PUBLIC INTEREST REVIEW FOR GROUND WATER APPLICATIONS

TO: Water Rights Section Date 17 June 2015
 FROM: Ground Water/Hydrology Section Gerald H. Grondin
Reviewer's Name
 SUBJECT: Application G- 17968 Supersedes review of _____
Date of Review(s)

A. GENERAL INFORMATION: Applicant's Name: Eleanor Fitzgerald, Fitzgerald Ranch Inc. County: Lake

LAKE 1886
T36S/R24E-sec 33 abb
Plush-Hart Lake Area
(Taylor Ranch, Inc.)

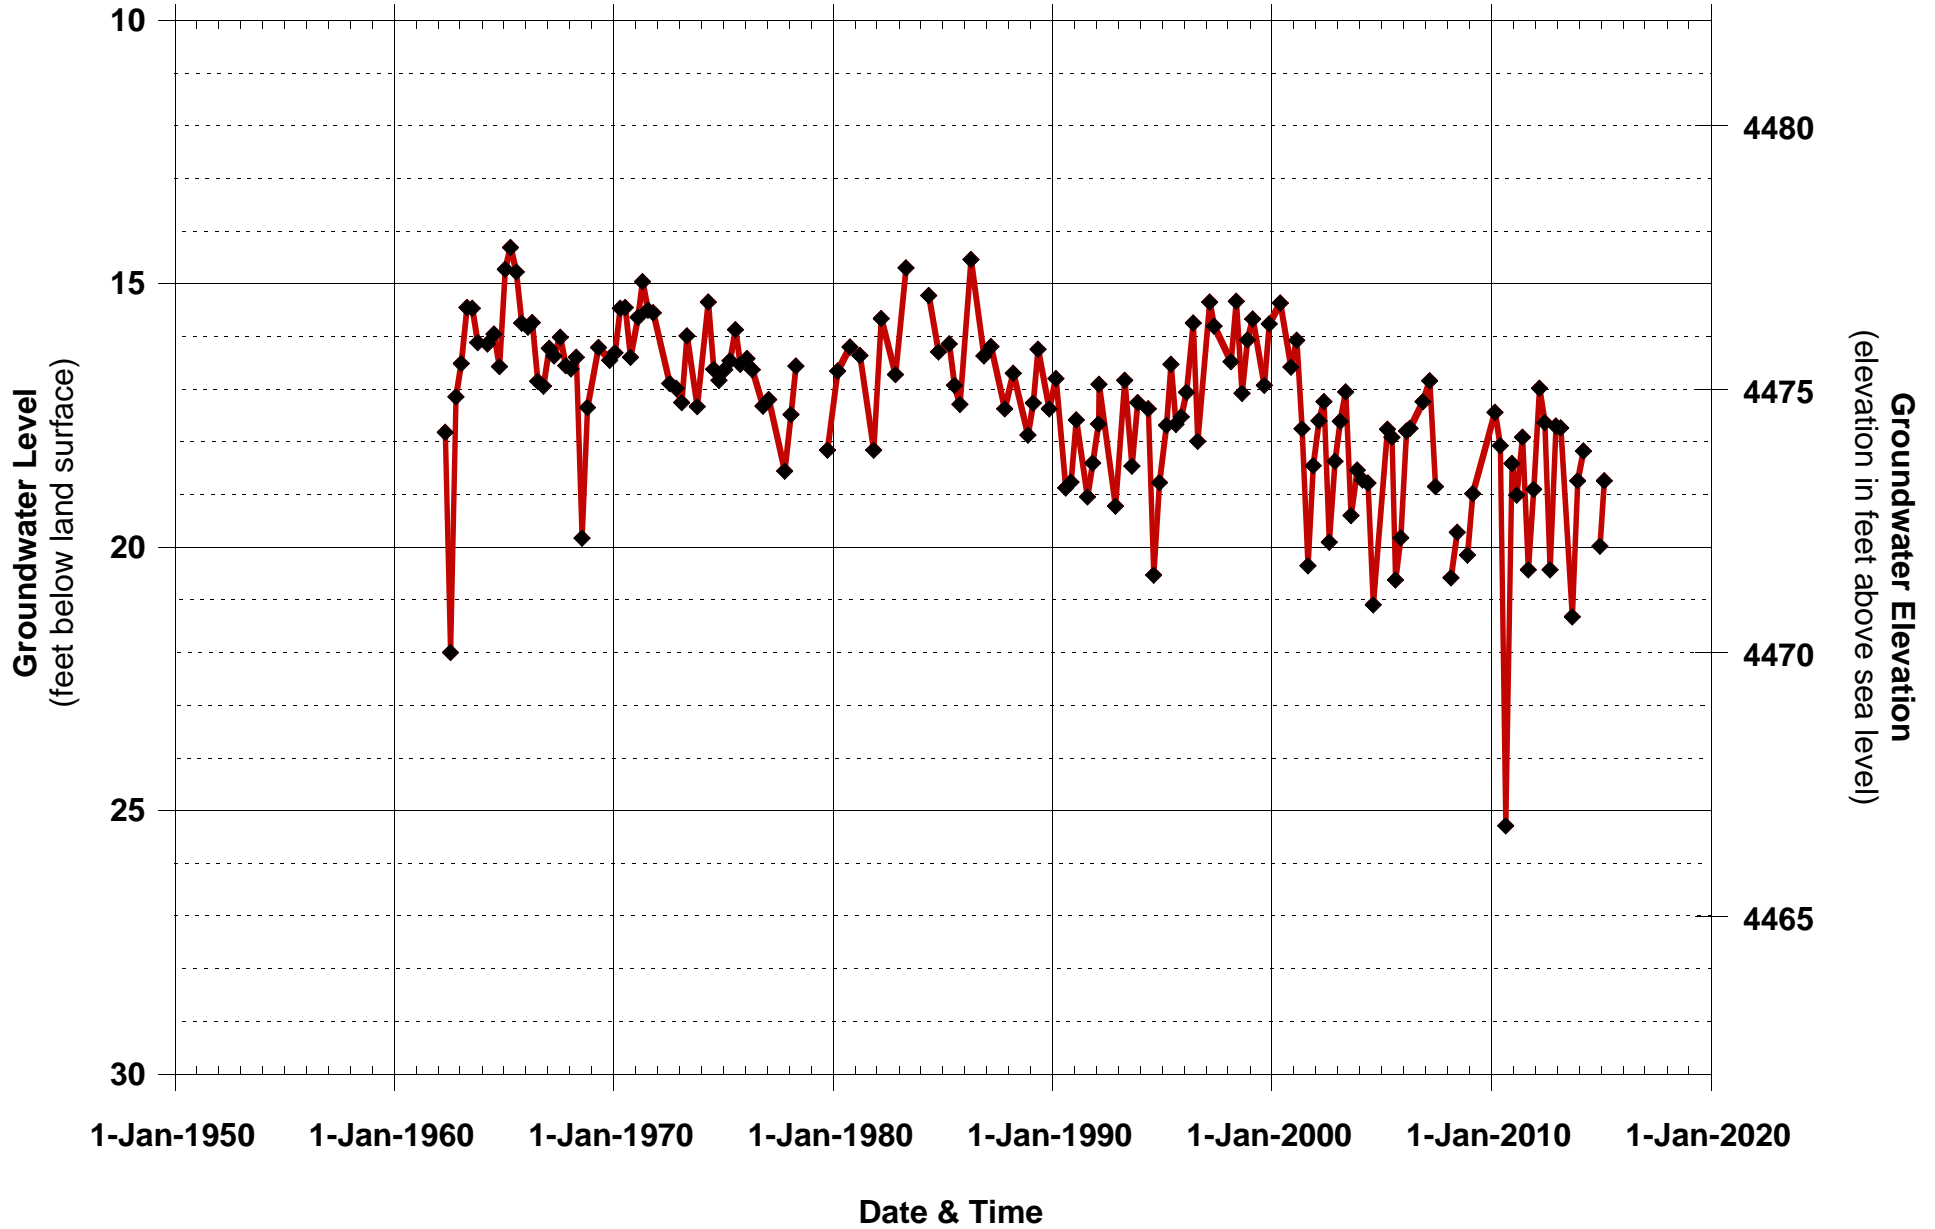
The state observation well with long term data (early 1960s to 2015) closest to the proposed POA well is state observation well 377 (well LAKE 1886) located in T36S/R24E-sec 33 abb about 2.7 miles south of the proposed POA well. The water level data for the well shows long term climate influences as well as annual seasonal influences. Before the 2000, peak annual groundwater levels were generally between 15 and 17 feet below land surface at the well. After 2001, the peak annual groundwater level has often been from 17 to 19 feet below land surface at the well. Climate may be partly to entirely responsible for the lower annual peak levels after 2001. Ongoing groundwater level measurements will help that determination.

Special Groundwater Reference Level Condition: “The Groundwater Reference Level at proposed the POA well (LAKE 52568) shall be 5.75 feet below land surface based on the 18 march 2015 measurement at that well.”

Proposed POA to Honey Creek

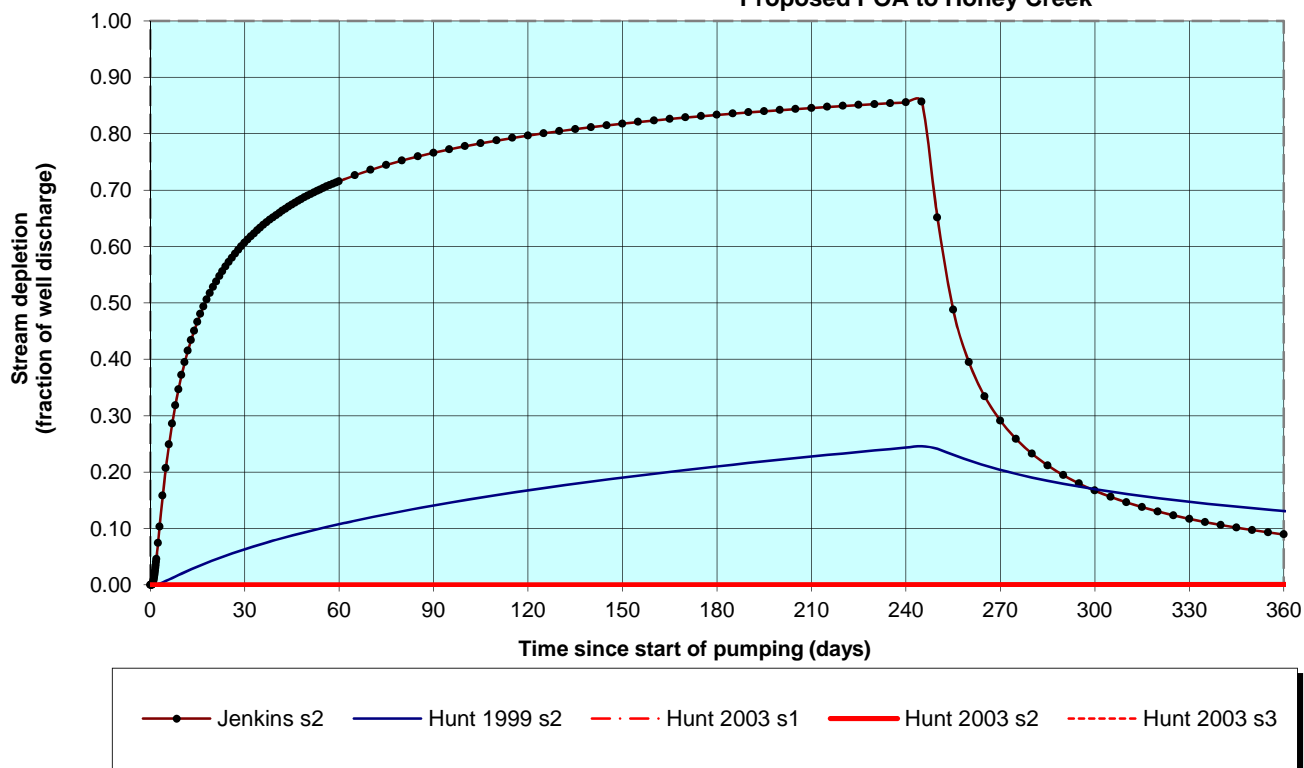
Analysis is done in this section given the proposed POA well is more than 1.0 mile from Honey Creek, Anderson Lake, and Hart Lake.

The Table above was used for interference with Honey Creek only given it is the water body in the area with water availability data.

A pro-rated pumping rate of 2.26 cfs (1,015 gpm) was used for the pumping rate. The pro-rated rate is the maximum annual volume of water allowed (1,099.2 ac-ft) divided the total time (245 days). This distributes the pumping over the entire proposed irrigation season. The results of 0.00% and 0.000 cfs indicate the calculated interference was less than 0.0005 cfs.
